ADDENDUM TO THE CONTRACT

**MELVIN PARK LIGHTING UPGRADE
Contract No. BE23-022**

ADDENDUM NO.: ONE

January 9, 2023

DRAWING #:
E-13
SHEET
13 OF 13

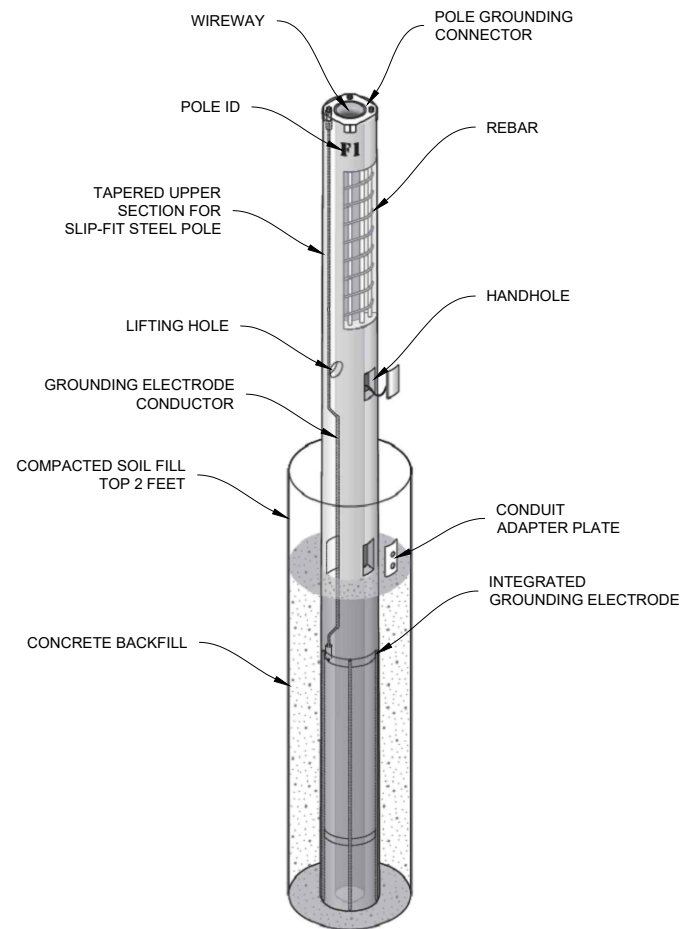
Item 1 Drawing E-13 titled "FOOTING & JUNCTION BOX", **Delete and Replace** with attached Drawing labeled "ADDENDUM 1".
